SDA Notes

SDA Comments & Criticisms

Author: Allan Hunter

Dated: 2 May 2021

Figure 6 – A90 Wheelchair Sketchup Model Source

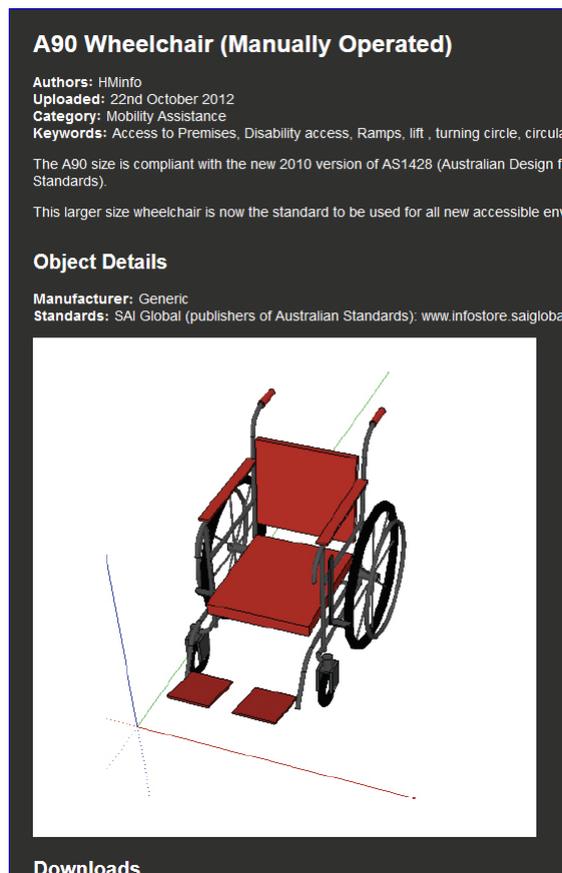
- **Adjustable Workbench** (clause 8.7). The requirement (allegedly a minimum requirement) is that the benchtop surface be adjustable from 720 mm to 1020 millimetres clear space underneath. This appears excessive. As a check, the A90 wheelchair use for standards development (Figure 6¹²) sketch up model was measured. The seat height is 367 mm above floor level. This leaves a gap of (1020 - 367 = 653 mm) of **more than half a metre** for cushion and thighs.

This is clearly not a minimum requirement, but I suspect reflects the capability of a (expensive ?) proprietary movable benchtop arrangement. A good example of an unnecessary expense being mandated under the guise of a “minimum standard”.

[Incidentally, the figures for my (large) electric wheelchair are 450 mm to the top of the seat base, and 690 mm to the top of the thighs. And I generally work on 750 mm minimum clearance for tables and bench tops. So how tall/large would someone be to require a knee clearance of over 1 m?]
